RIGHT OF WAY PLAN OF THE HOLBROOK - SPRINGERVILLE STATE HIGHWAY

PROJECT NO. F-051-1-809

APACHE COUNTY

HOLBROOK — SPRINGERVILLE HWY.
BEAVER DAM WASH — HUNT SECTION
APACHE COUNTY

PROJECT NO.	F-051-1-809
DRAWING NO.	D-1-T-241
SHEET NO.	10 of 23
DRAWN BY	E.B.S.
DATE COMP.	8-29-69
SCALE	1" = 100'
CONSULTANT	GREER ENGR. CO.

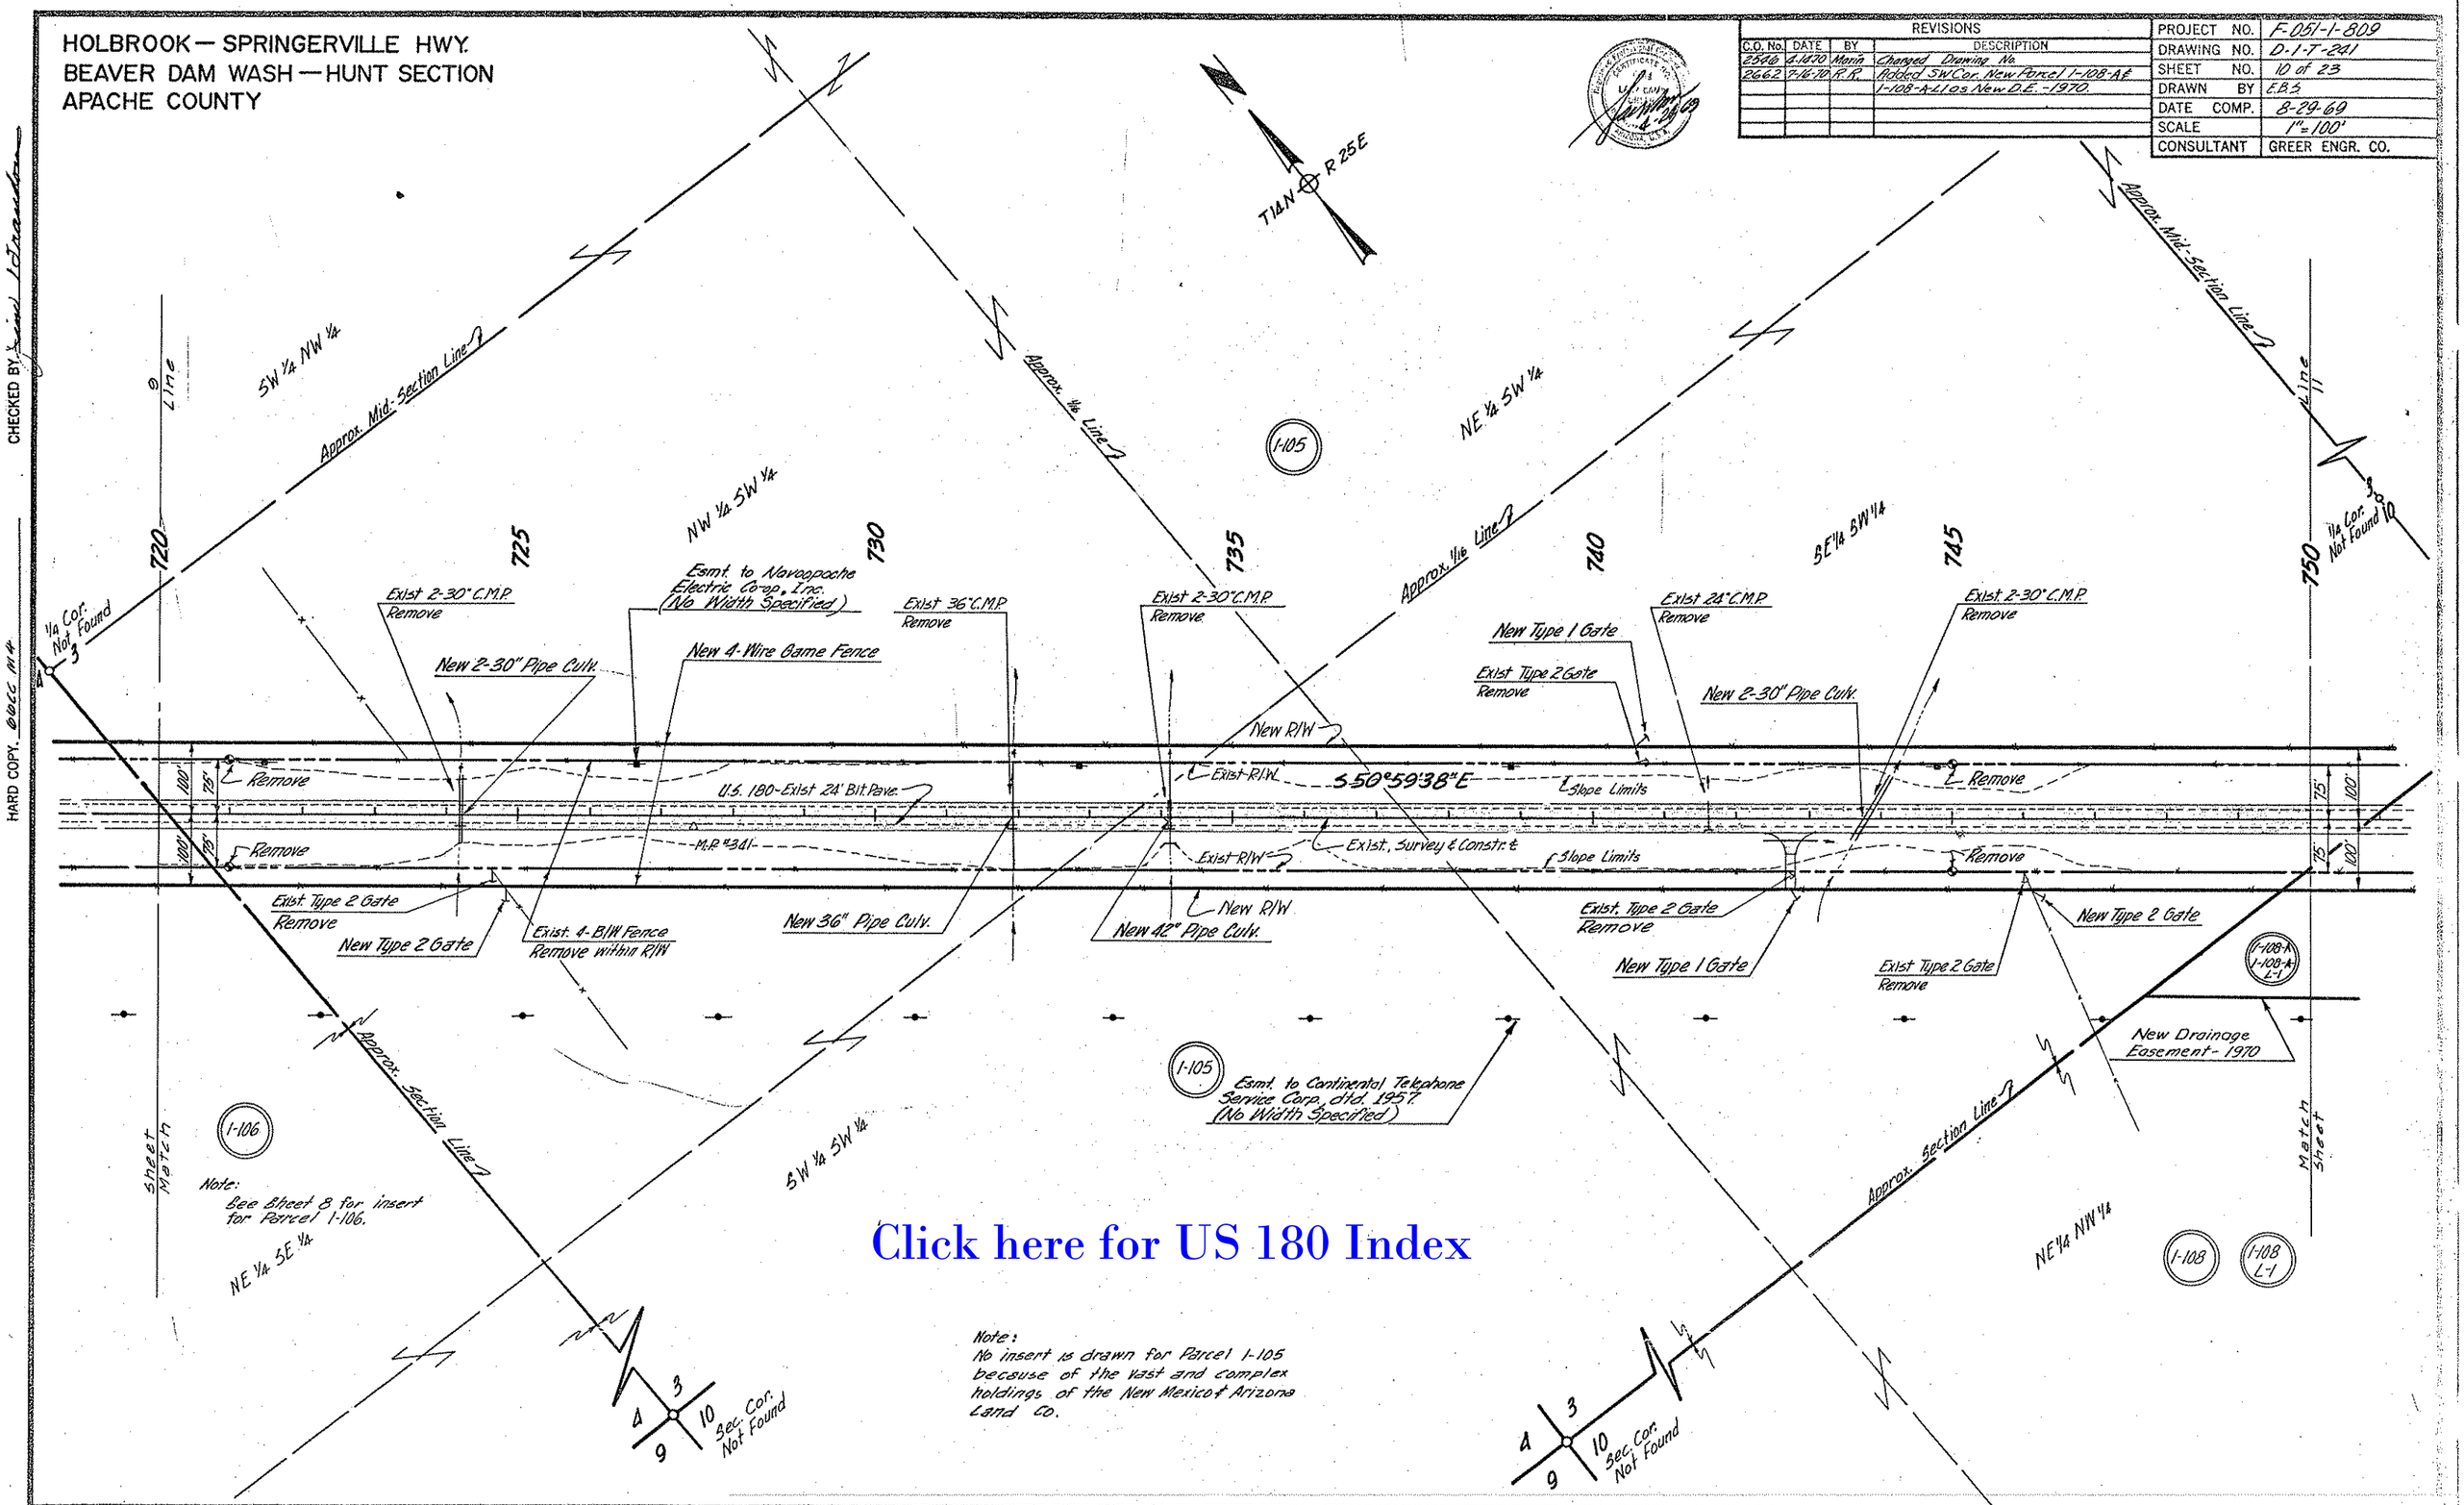
REVISIONS			
C.O. No.	DATE	BY	DESCRIPTION
2590	4-14-70	Marin	Changed Drawing No.
2662	7-16-70	R.R.	Added SW Cor. New Parcel 1-108-A & 1-108-A-L1 as New D.E. - 1970.

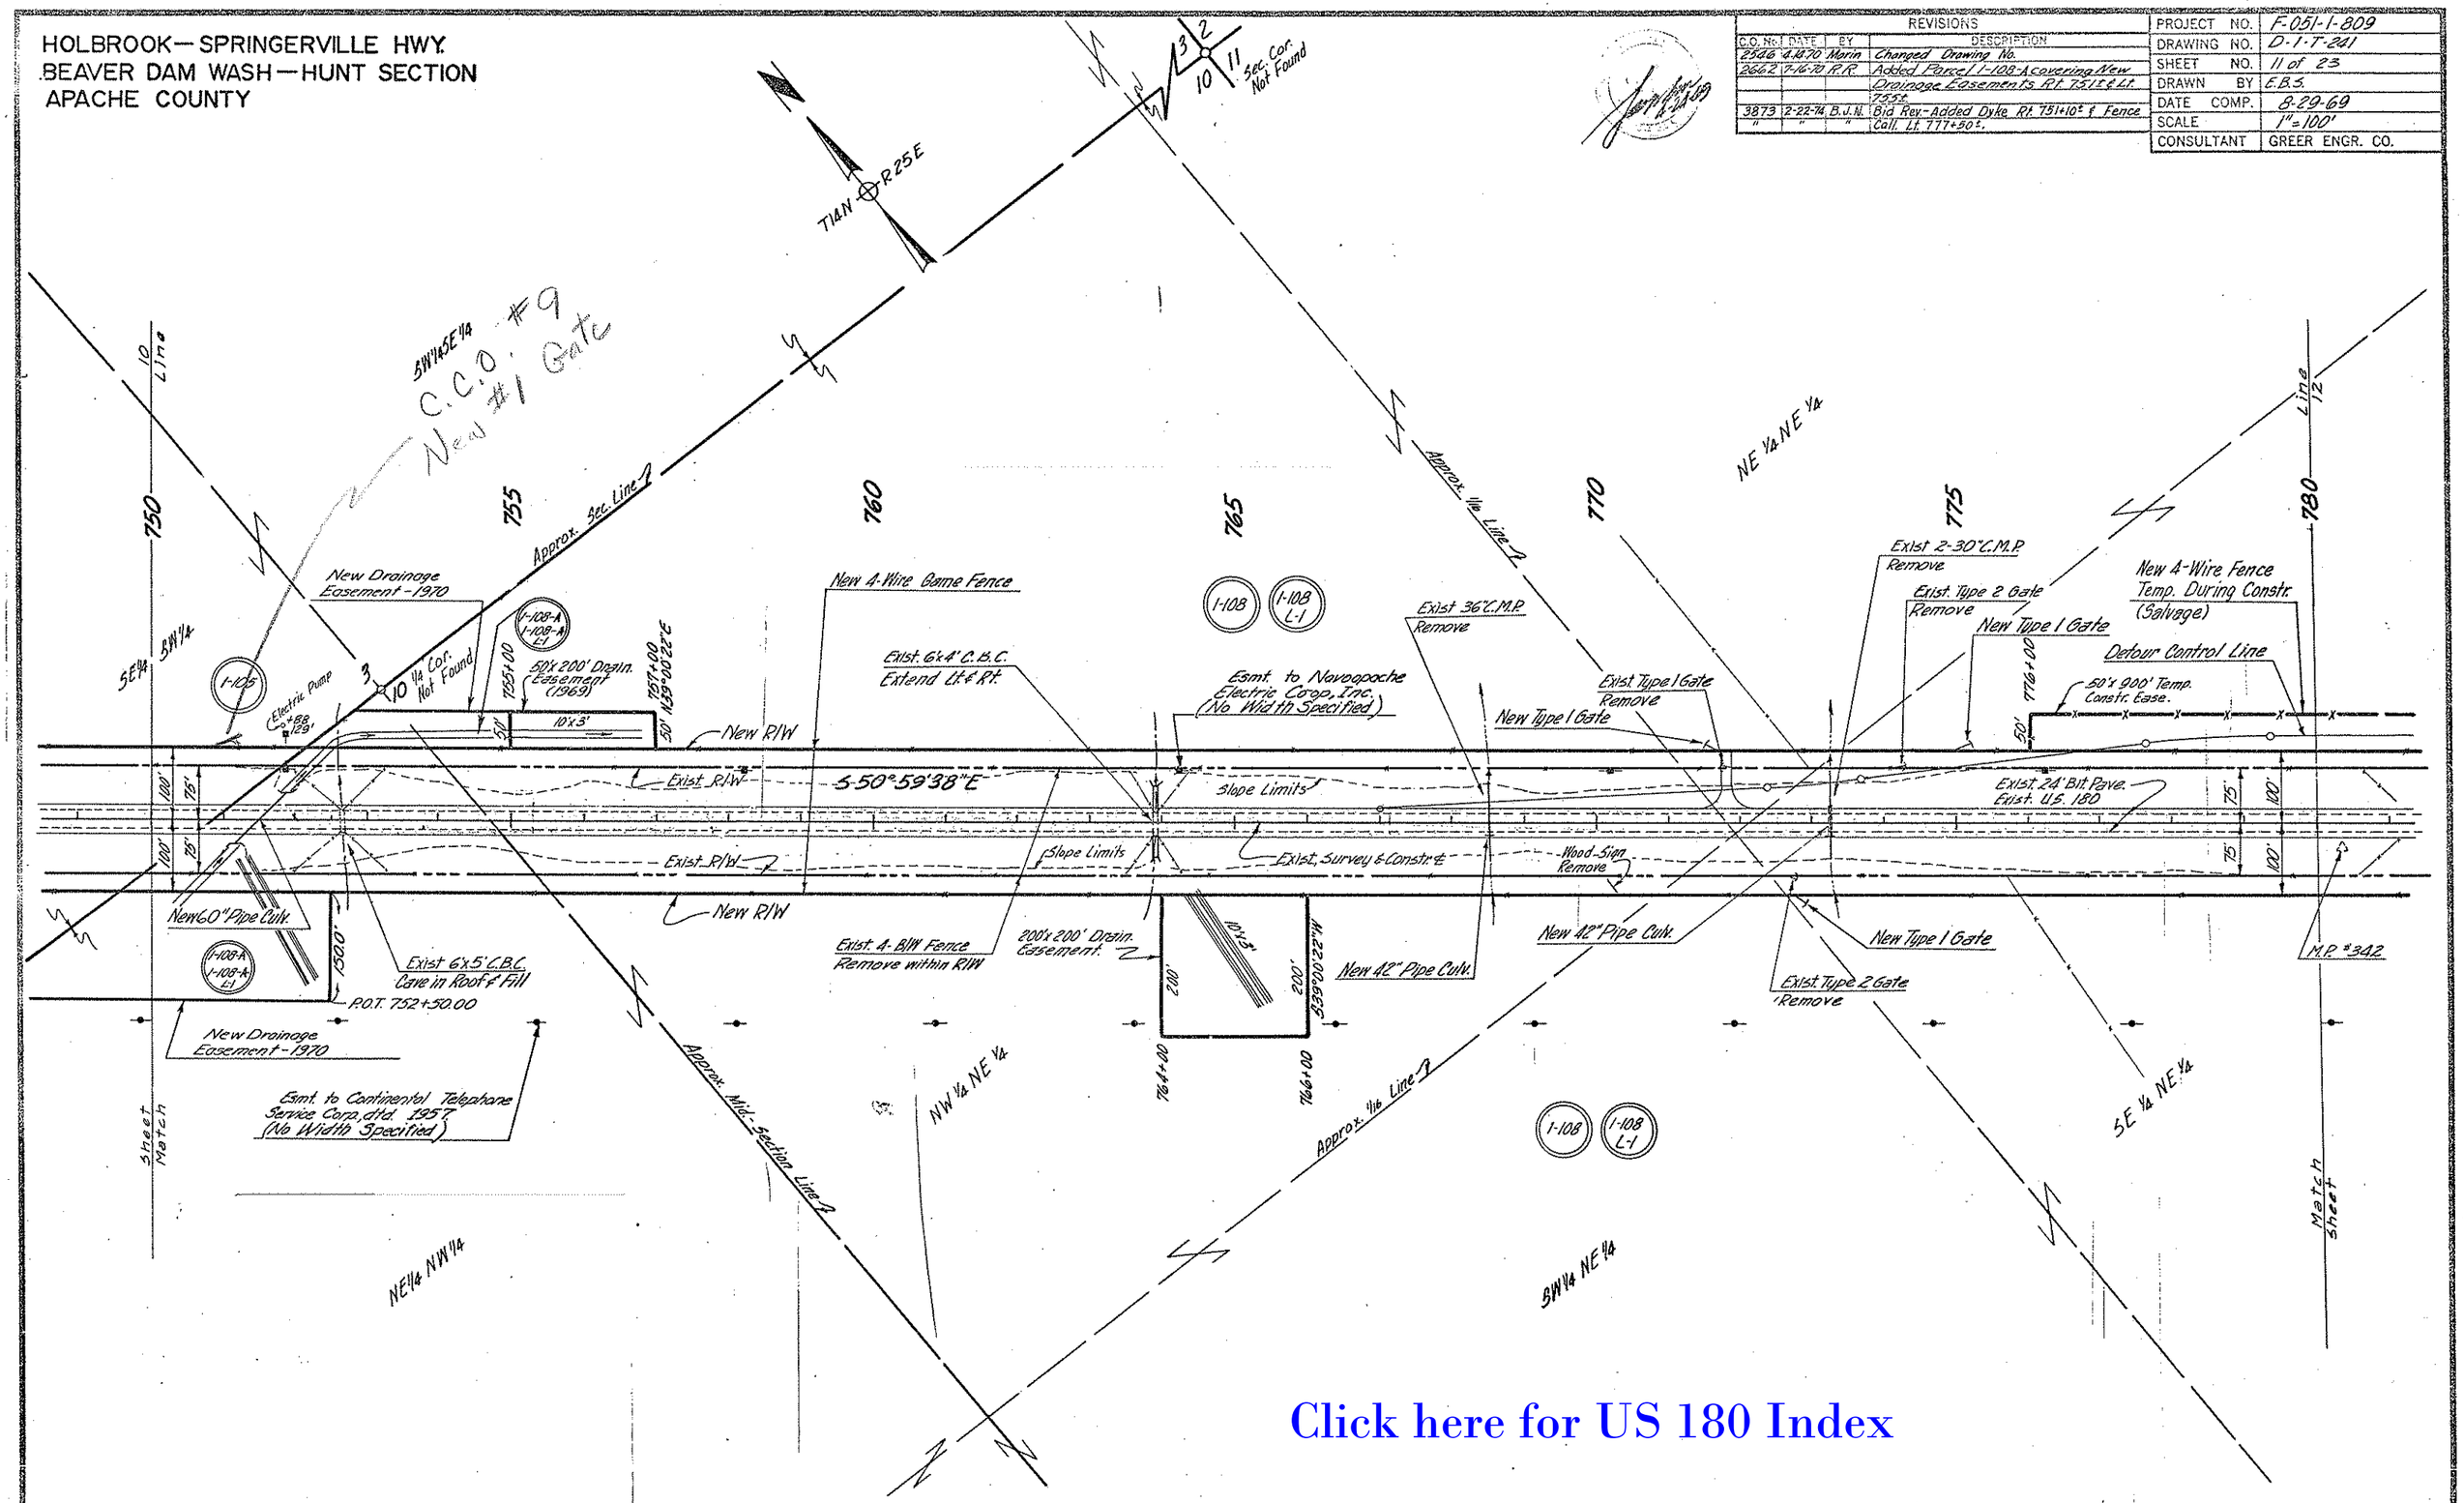
REVISIONS				PROJECT NO.	F-051-1-809
C.O. No.	DATE	BY	DESCRIPTION	DRAWING NO.	D-1-T-241
2546	4-18-70	Morin	Changed Drawing No.	SHEET NO.	11 of 23
2662	7-16-70	R.R.	Added Parcel 1-108-A covering New Drainage Easements Rt. 751± & Lt. 755±	DRAWN BY	E.B.S.
3873	2-22-74	B.J.N.	Bid Rev-Added Dyke Rt. 751+10± & Fence Call. Lt. 777+50±.	DATE COMP.	8-29-69
"	"	"		SCALE	1" = 100'
				CONSULTANT	GREER ENGR. CO.

PROJECT NO.	F-051-1-809
DRAWING NO.	D-1-T-241
SHEET NO.	12 of 23
DRAWN BY	E.B.S.
DATE COMP.	8-29-69
SCALE	1" = 100'
CONSULTANT	GREER ENGR. CO.

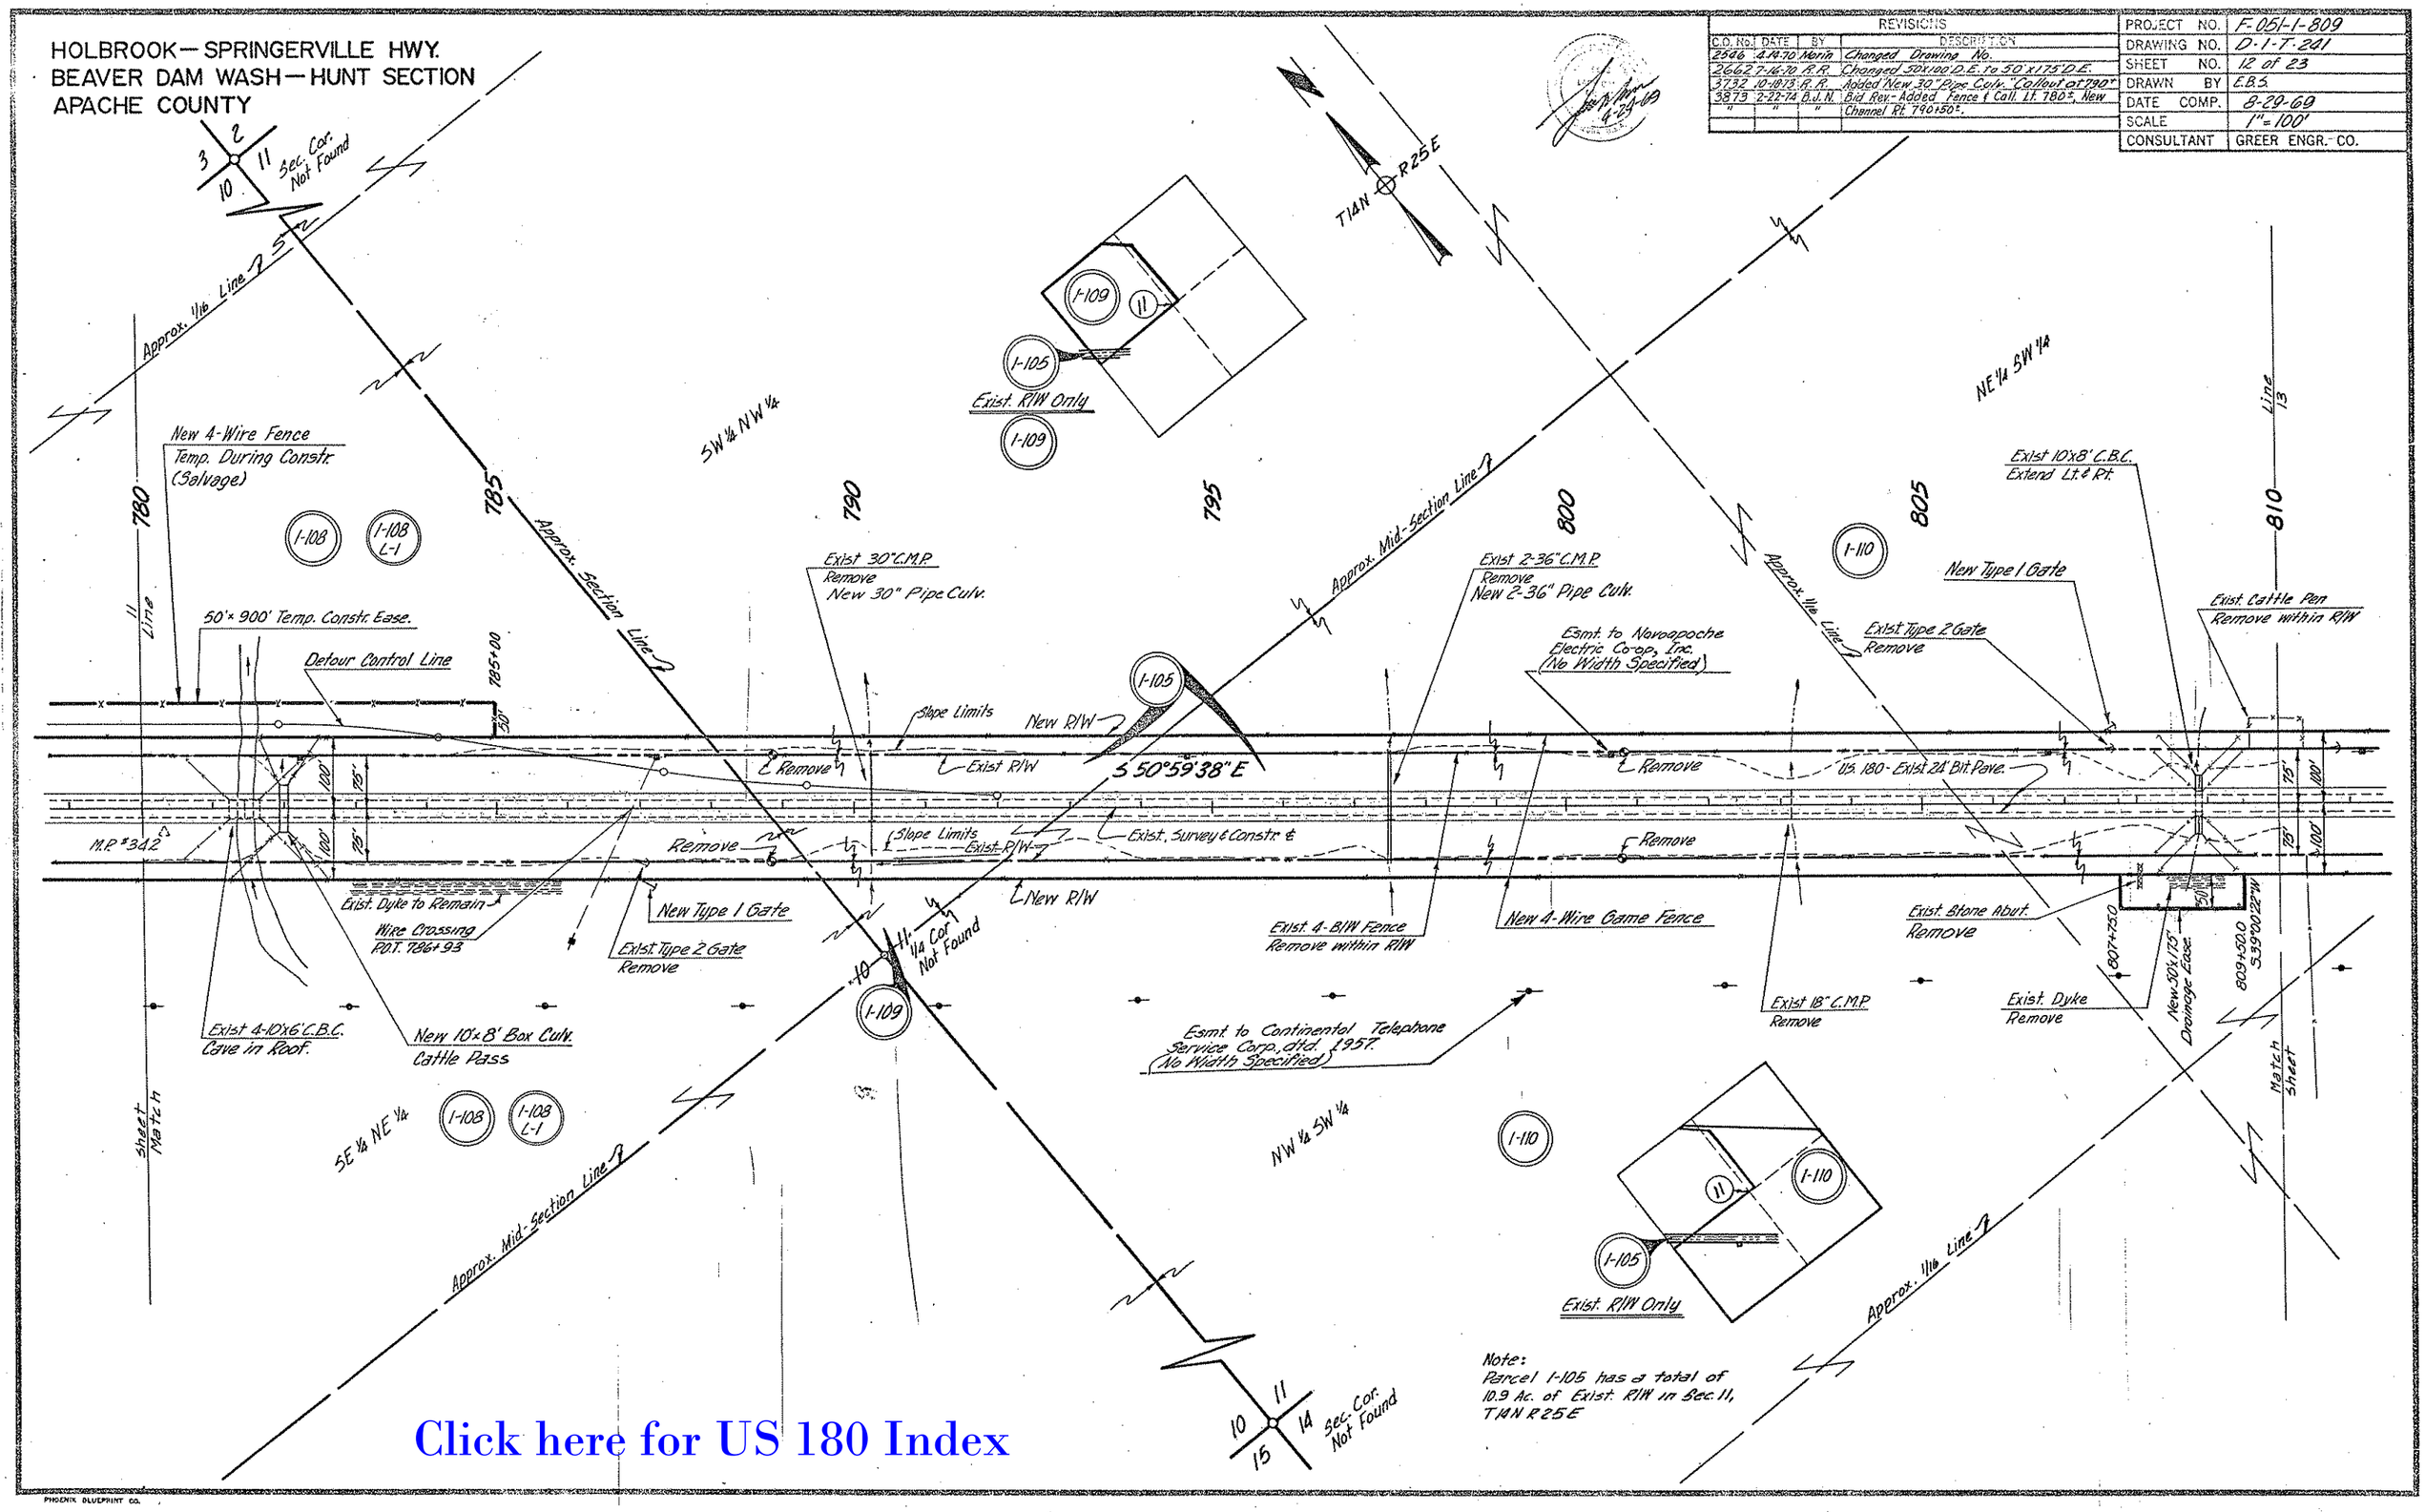
REVISIONS			
C.O. No.	DATE	BY	DESCRIPTION
2546	4-14-70	Morin	Changed Drawing No.
2662	7-14-70	R.R.	Changed 50'x100' D.E. to 50'x175' D.E.
3732	10-18-73	R.R.	Added New 30" Pipe Culv. Callout at 790+
3873	2-22-74	D.J.N.	Bid Rev.- Added Fence & Call. Lt. 780±, New
"	"	"	Channel Rt. 790+50±.
